Darling Square NW Plot
Design Report for Section 96 Application
(Mod 3) To Modify SSD 6013
October 2016

Approval for SSD 6013 Mod 2 was granted on 26 November 2015. This report has been prepared to support a section 96 application. It describes a range of minor amendments as the result of design development for the project.

Figure 3.05 : Section 96 NW Plot Proposed Unwrapped North, West and South Elevation

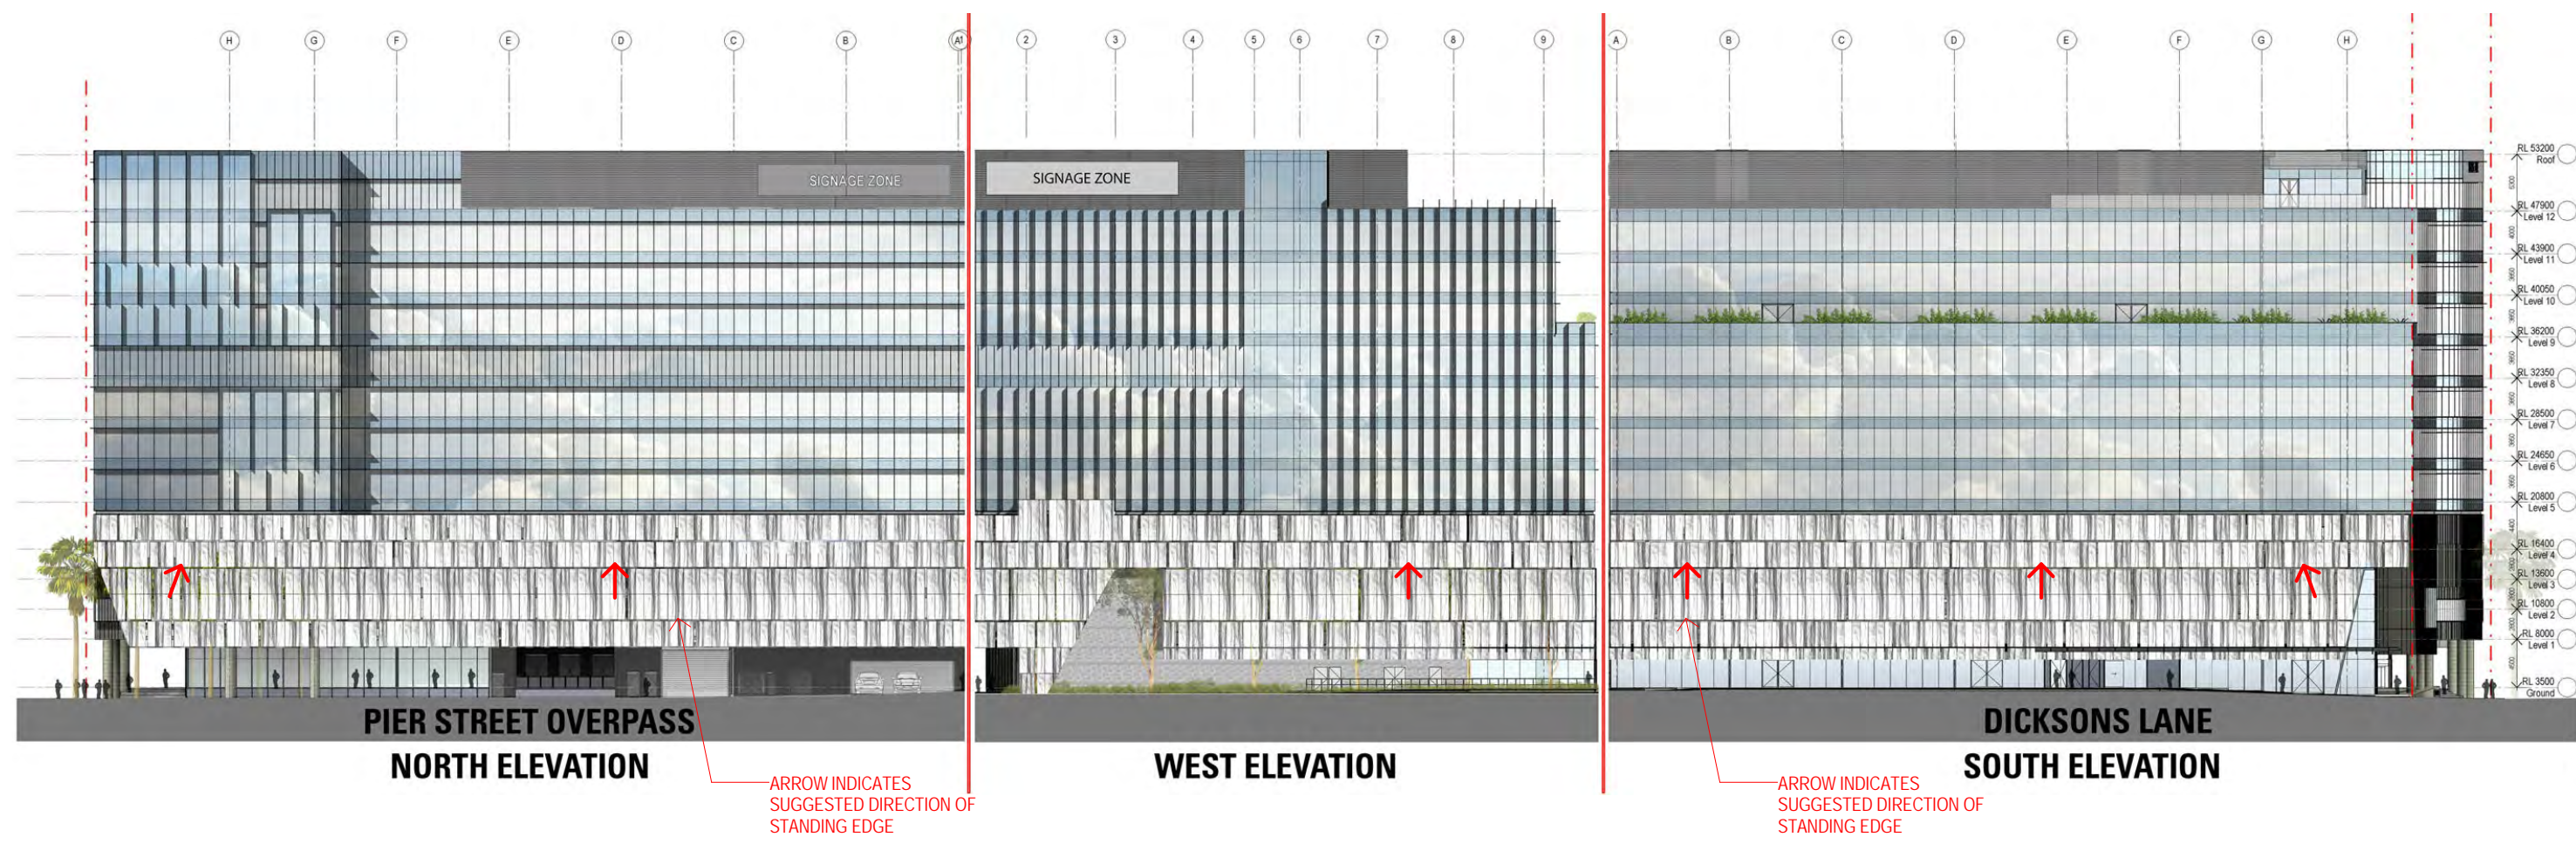
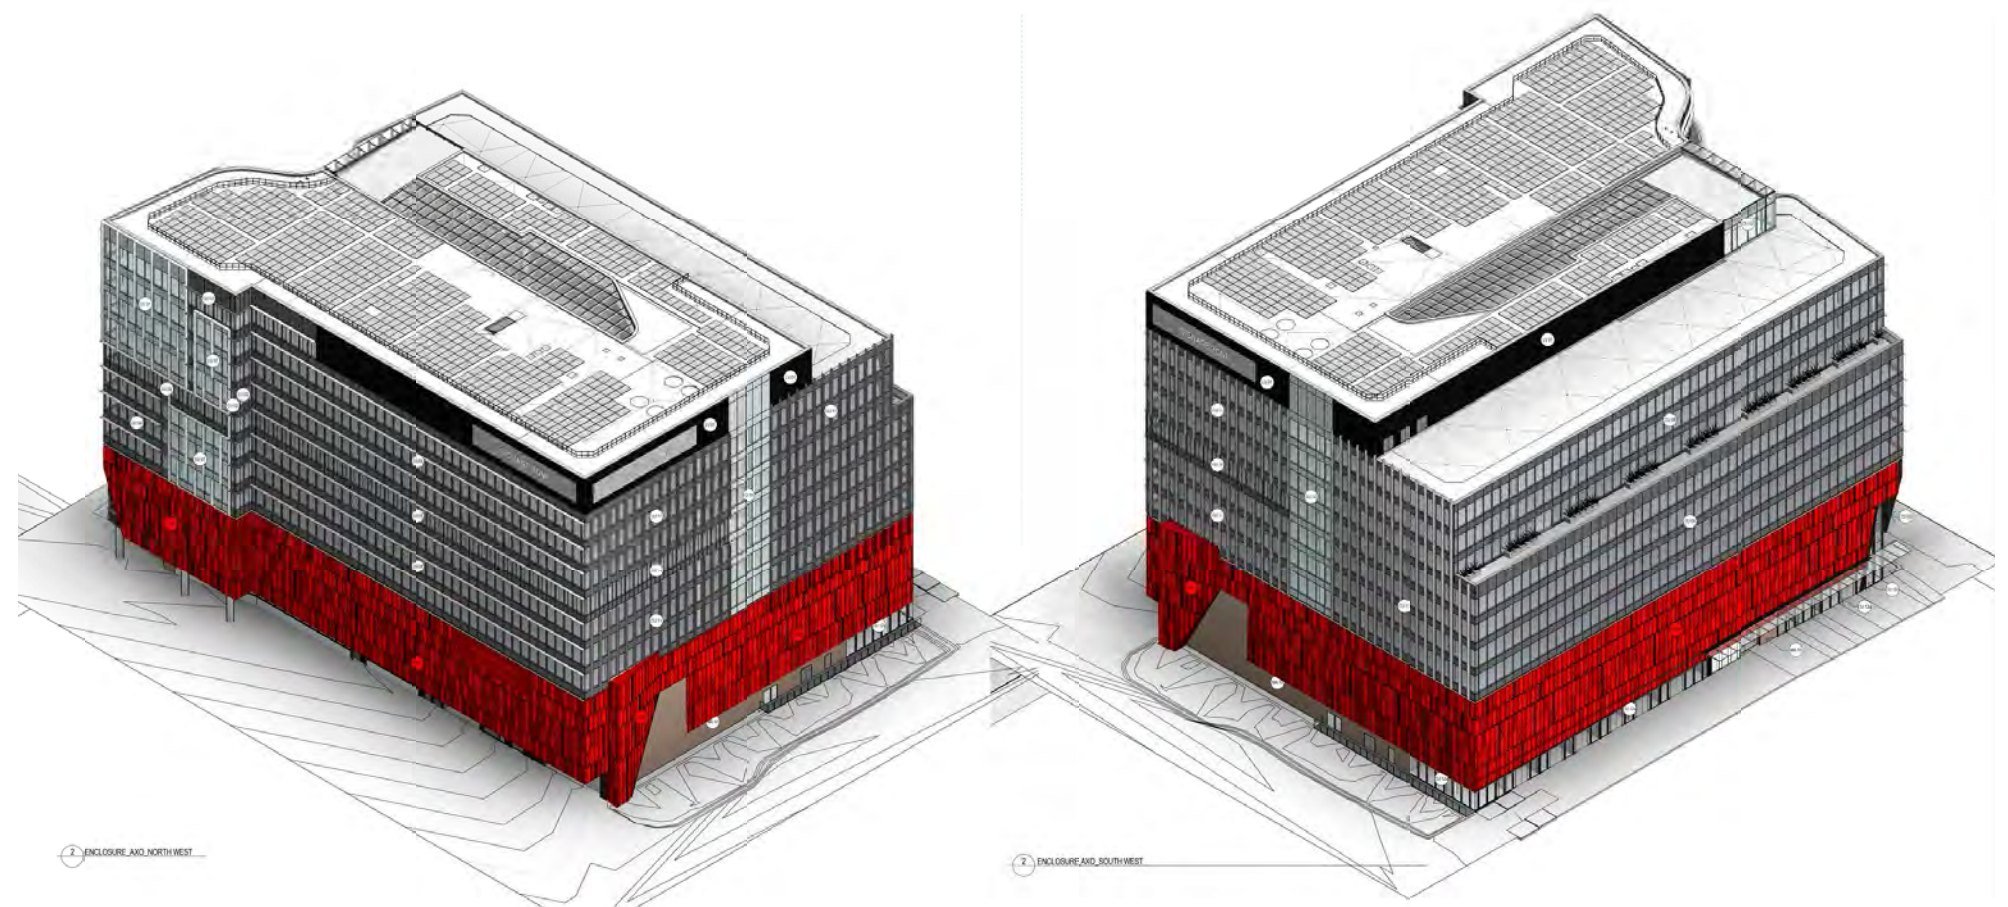
An alternative metal cladding material is now proposed to improve the building aesthetic whilst providing better screening to the car park behind on level 1 to 4 of the North, South and West elevations.

The carpark will be clad in an innovative aluminium cladding material which has screening properties, the opportunity to overlay artwork but still allows for natural ventilation.

The carpark levels 1-4 will be clad in the proposed 'Ombrae' system to the North, West and Southern elevations.

Figure 3.13 : Section 96 NW Plot Proposed Overall View of the Roof

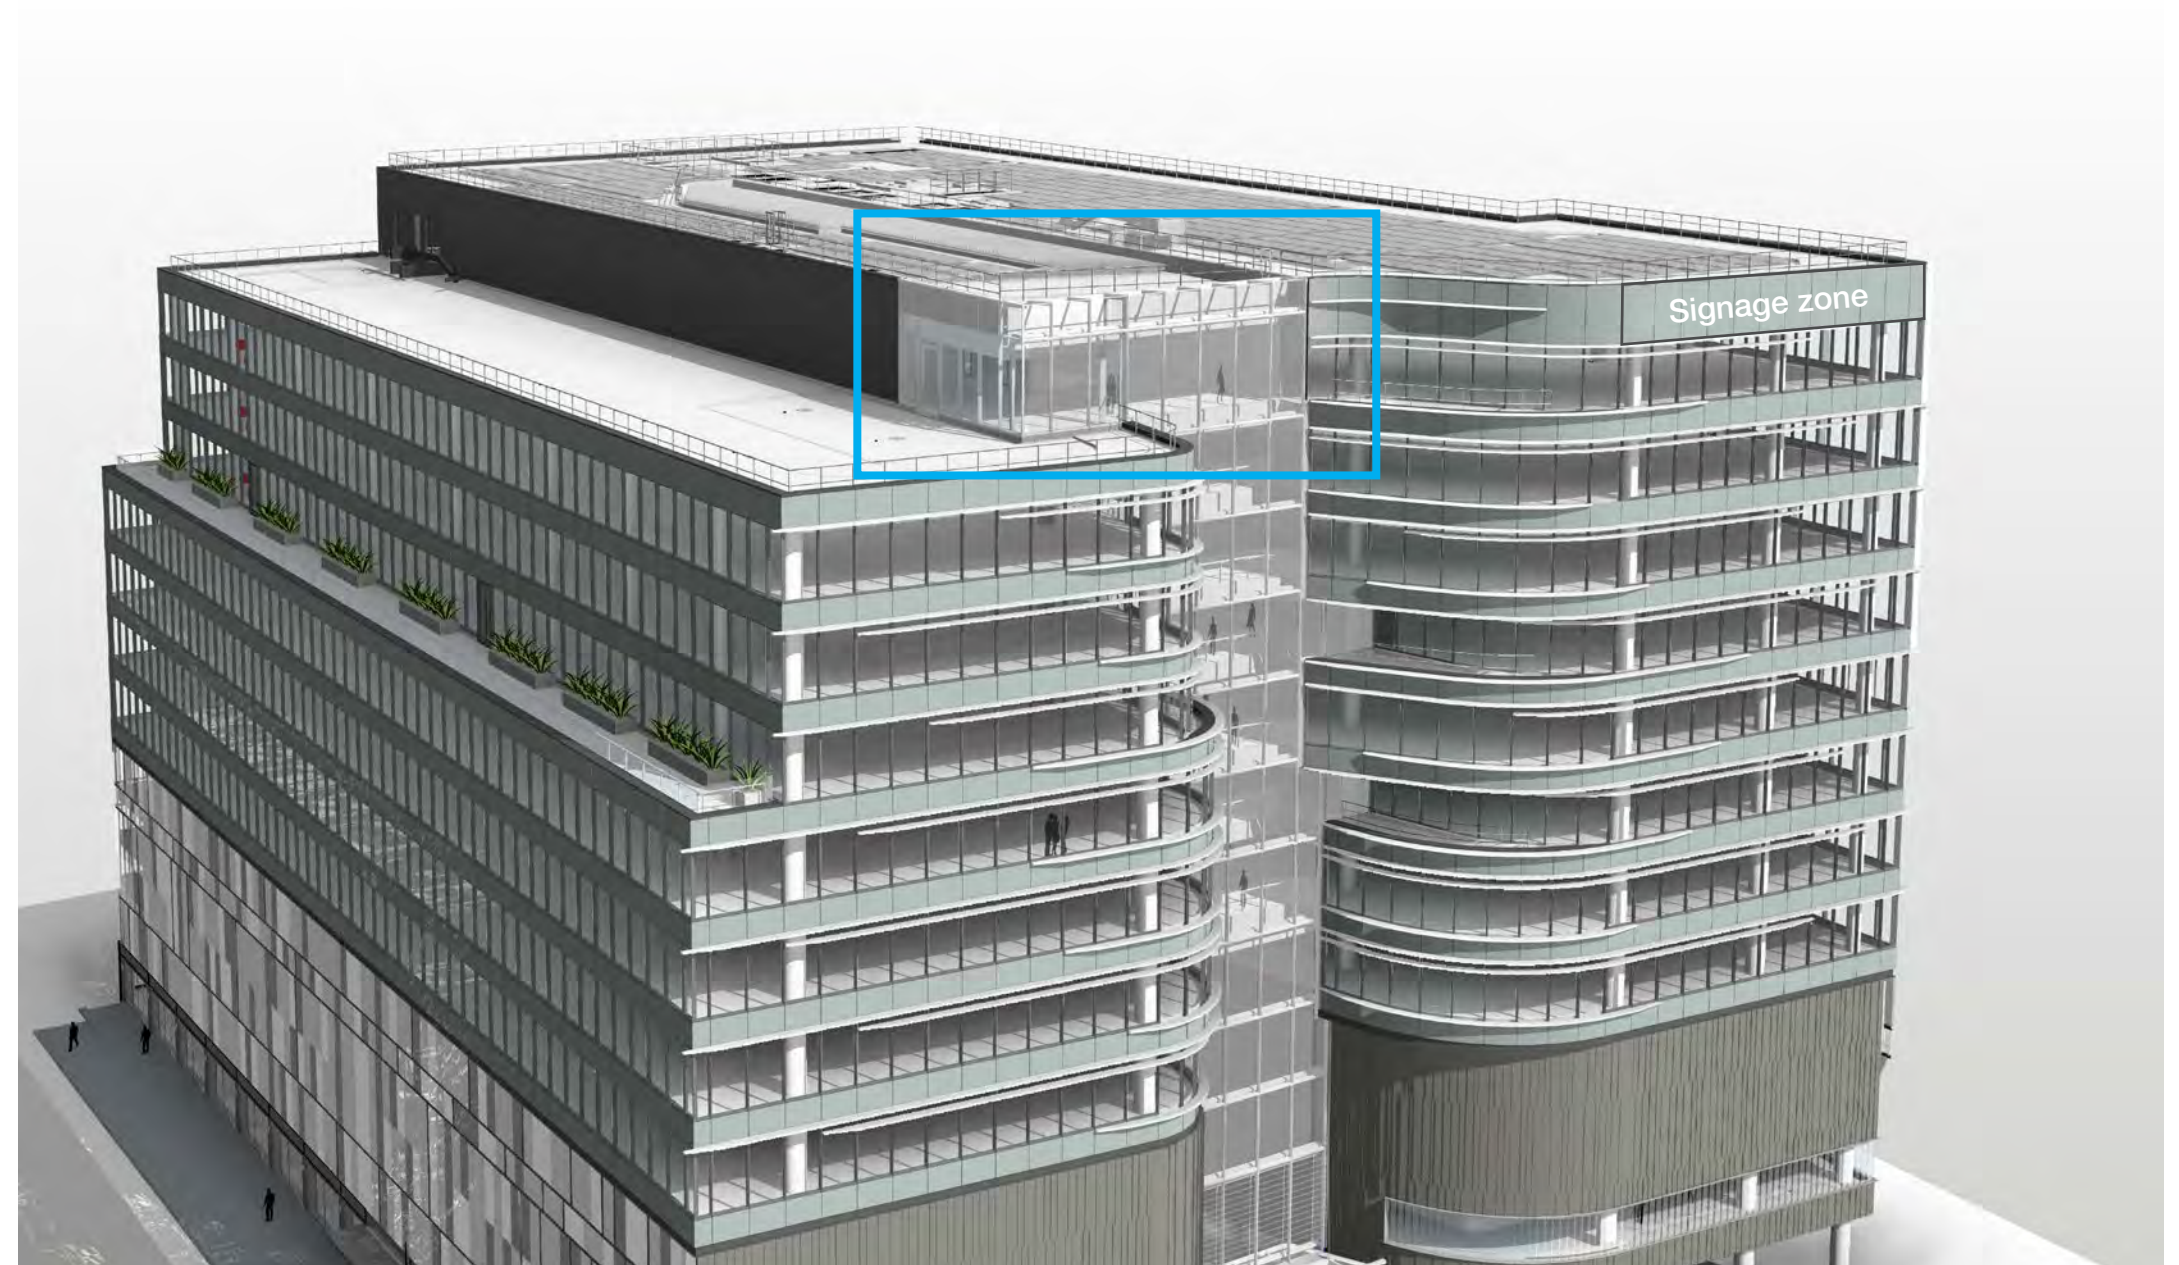
The top edge of the atrium roof of the Eastern facade has been better aligned to improve the architecture visually when reading the facade. The new alignment adjusts the atrium glazing to be in line with the core behind.

The core element was visible previously and disrupted the intent of having a view of unincumbered glazing that wraps over the building. The adjustment also further improves the look of the Southern Elevation.

The new alignment of this portion of the roof also benefits the interior space as the ceiling height can be consistent across the floor plate.

Figure 4.01 : Section 96 NW Plot Proposed Level 12 Plan

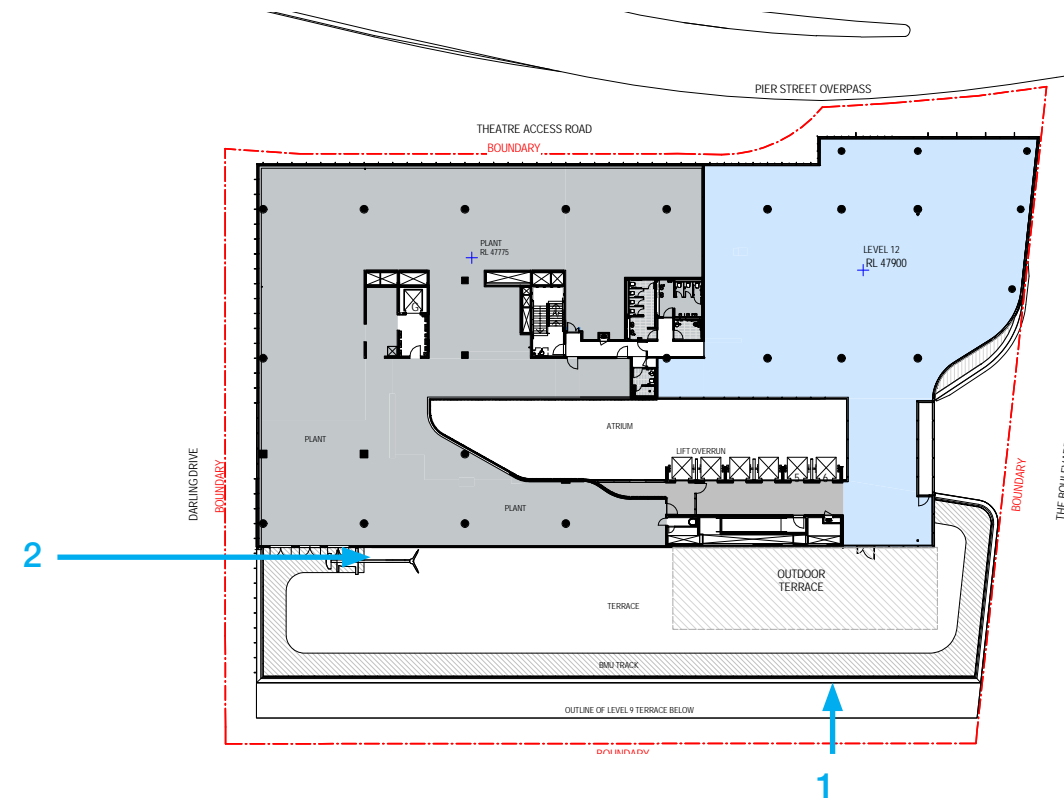
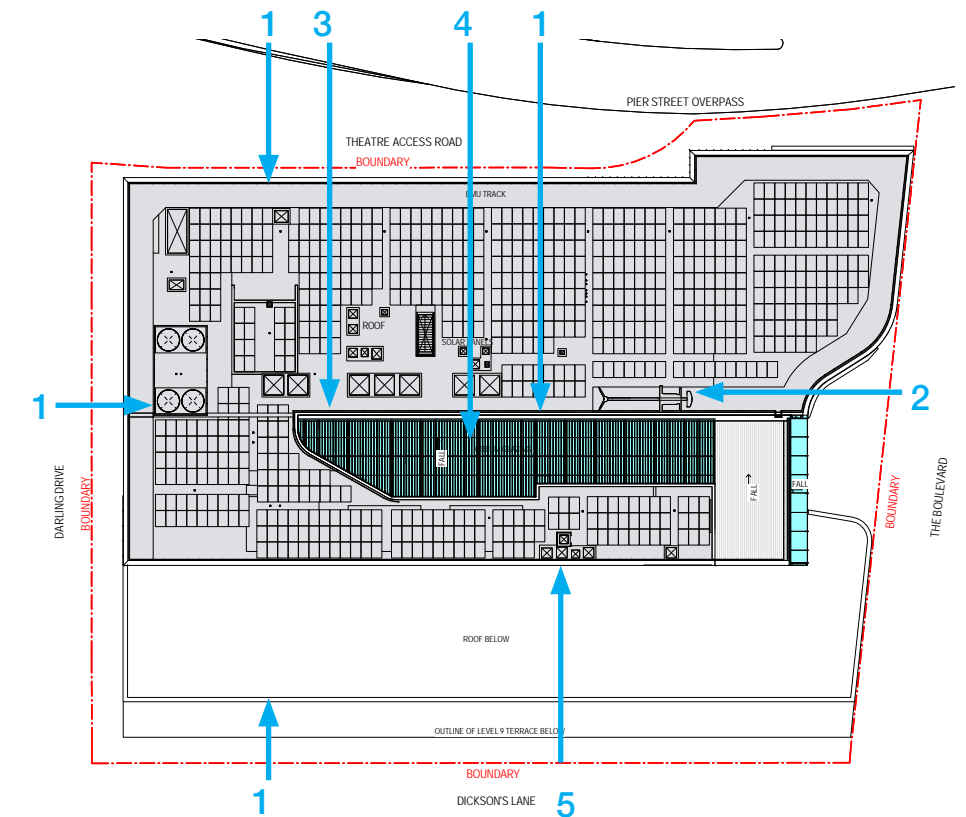
1. Locating fall protection balustrades around the perimeter of the level 12 and 13, around the ladder access and around the skylight.
2. Positioning the Building Maintenance Units (BMUs) at level 12 and 13; and
3. Realigning the West end of the atrium glazed roof to mirror the shape of the atrium within the building;
4. Adding automated louvres to the atrium glass roof; and,
5. Locating additional solar panels.

Figure 4.05 : Proposed Roof Perspective

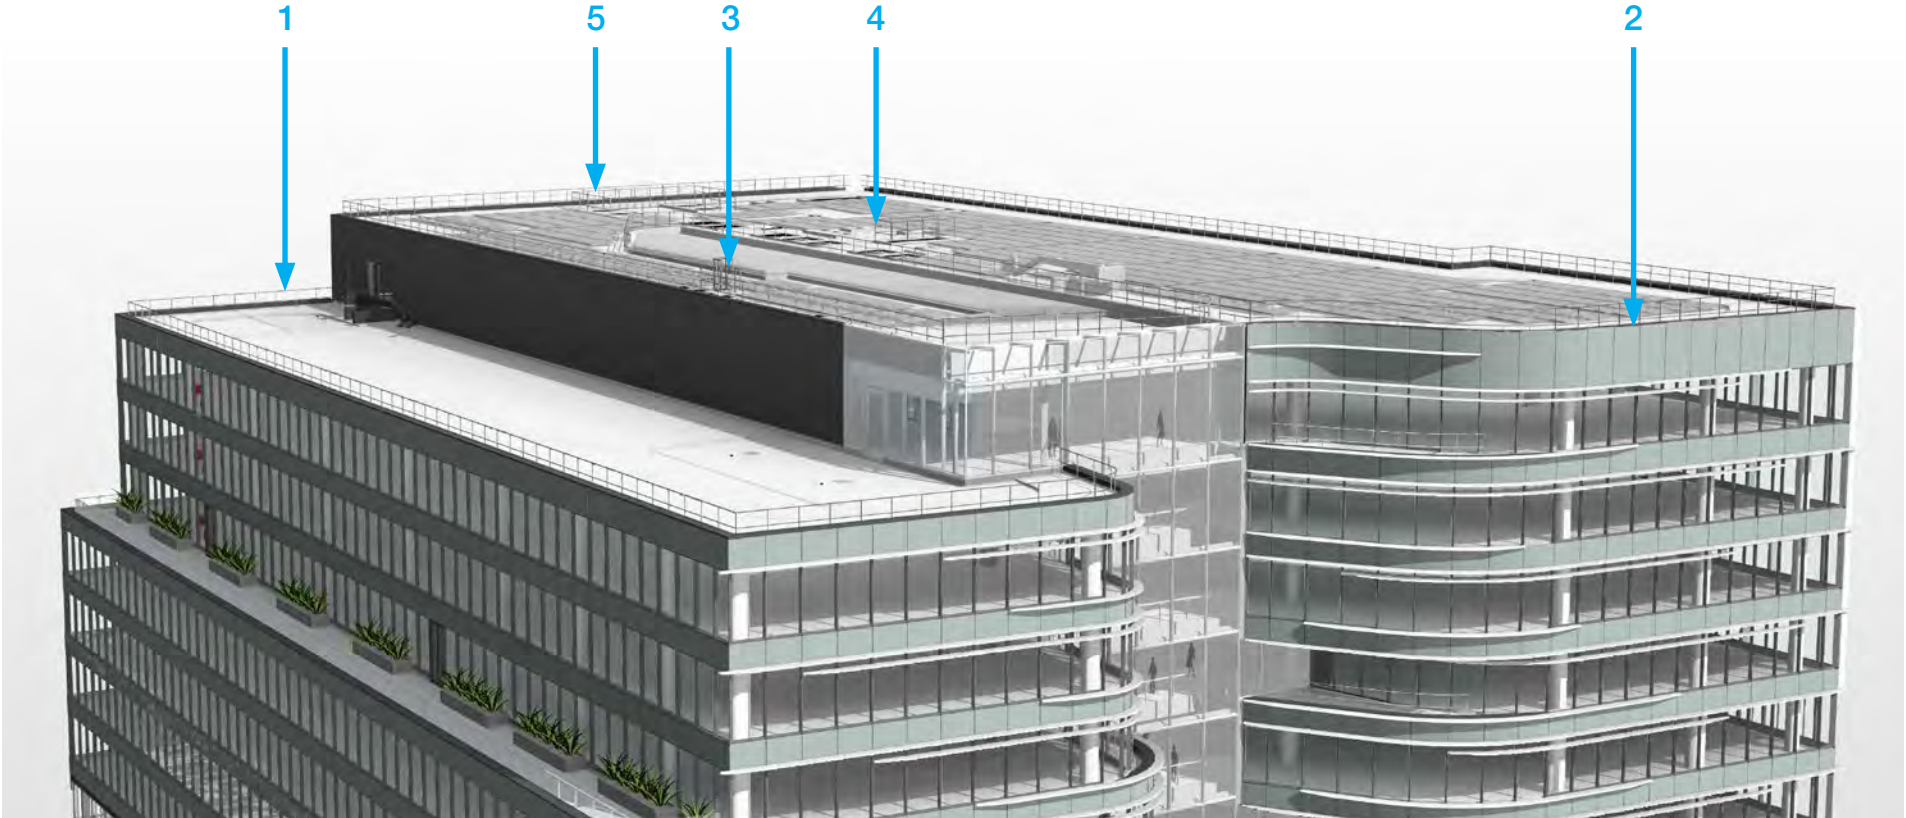
As part of the technical design development, additional roof ladder cages have been added to assist in fall protection for ease of maintenance and roof access where required.

To ensure safe continuous access to the roof areas of the building for maintenance purposes, balustrades have been incorporated to the areas noted below:

1. Edge balustrade to L12
2. Edge balustrade to roof
3. Ladder access to secondary roof access
4. Balustrade to stair access
5. Balustrade around Air Handling Units (AHUs)
